A. E. Co. TYPE 101 DIRECTOR  
OPERATION

1.01 This Addendum is issued to make changes in Section 240-205-105, Issue 2, in the General System Practices. Using ink or red pencil, make the changes as indicated in Part 2. In the margin adjacent to these changes, write "See Addendum." This addendum should then be filed ahead of Section 240-205-105.

Figure 4. Translator Interconnections.

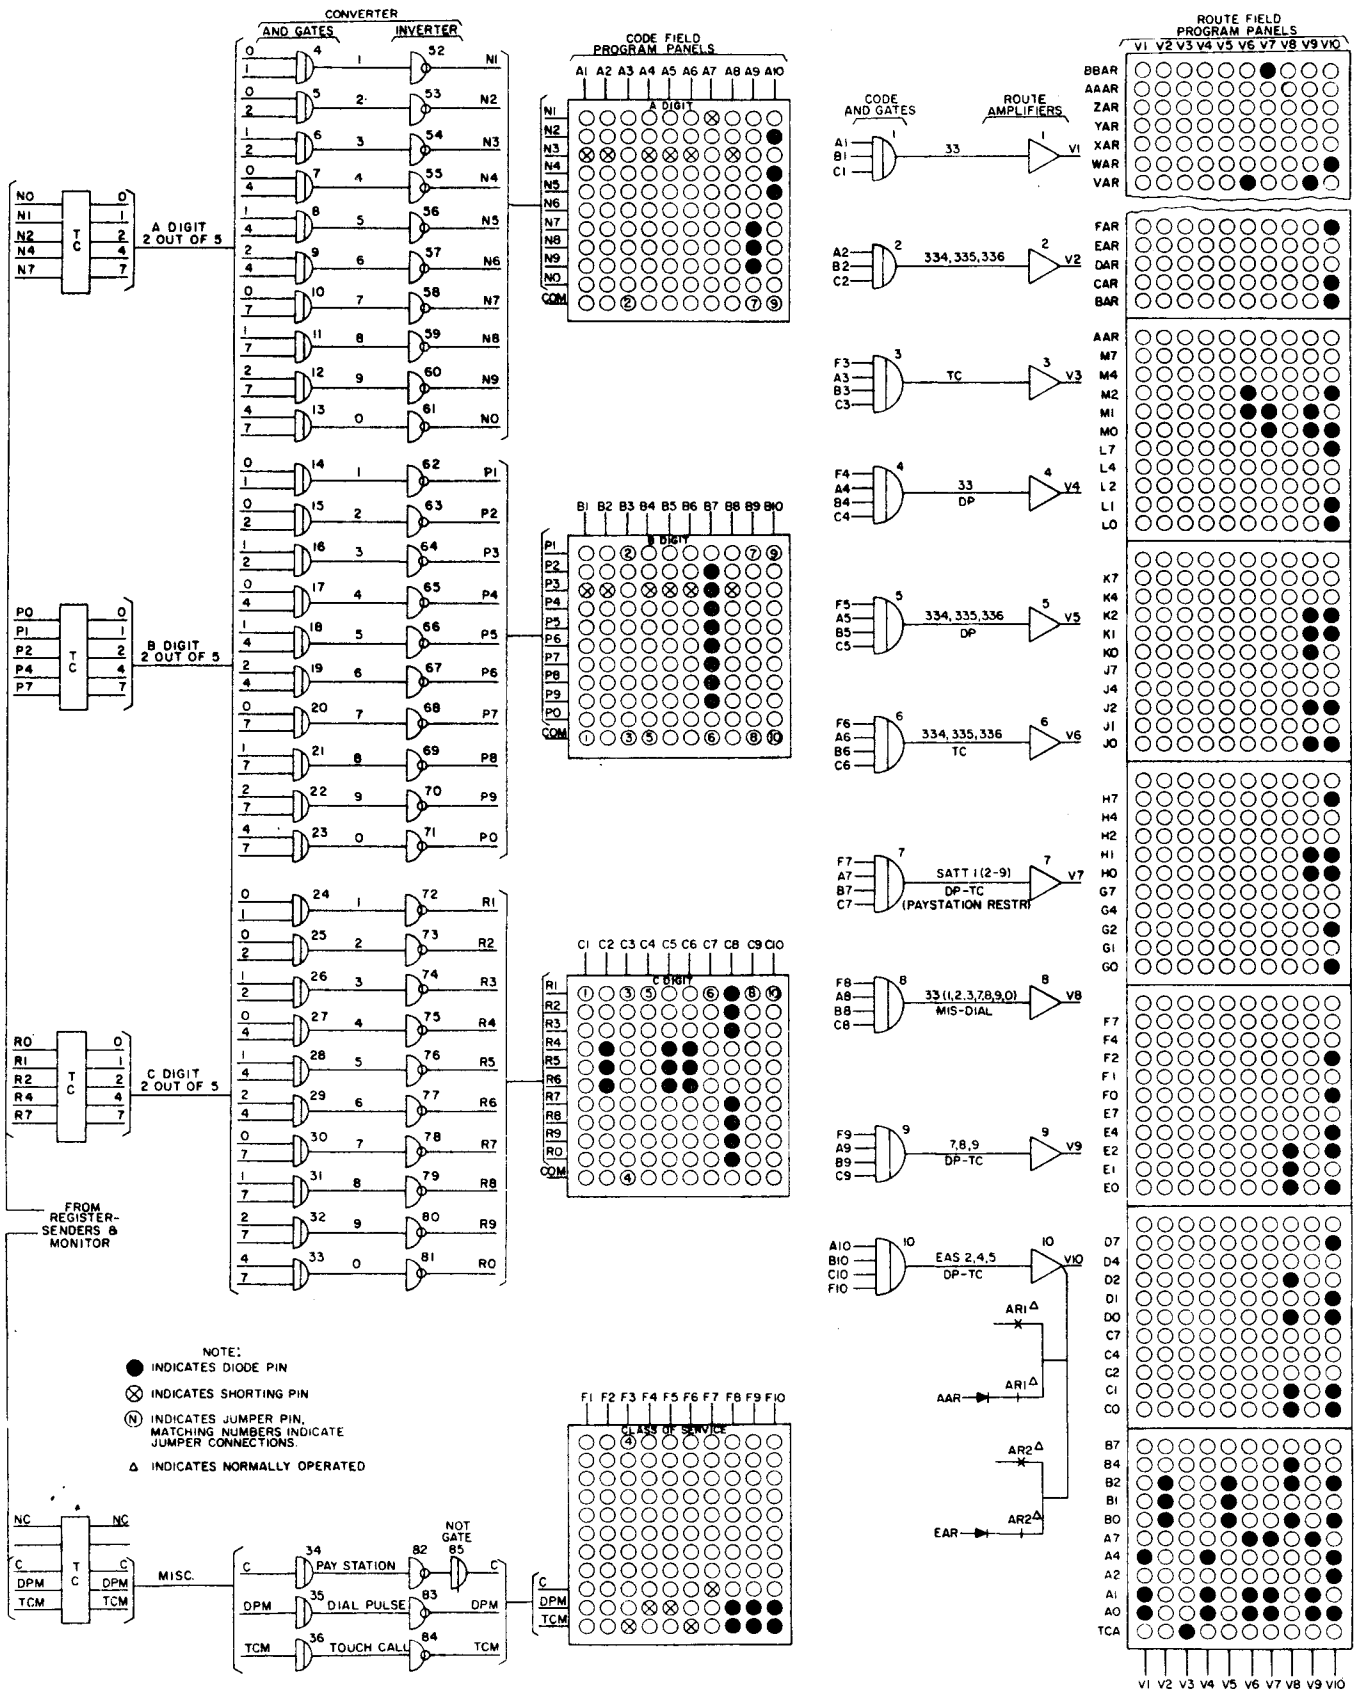
2.01 Cross out Figure 4. The new Figure 4 changes the positions of route diode pins

V7/ZAR and V9/WAR to V7/BB-AR and V9/VAR, respectively. Designation, NOT GATE, is also changed to read NOT GATE 85.
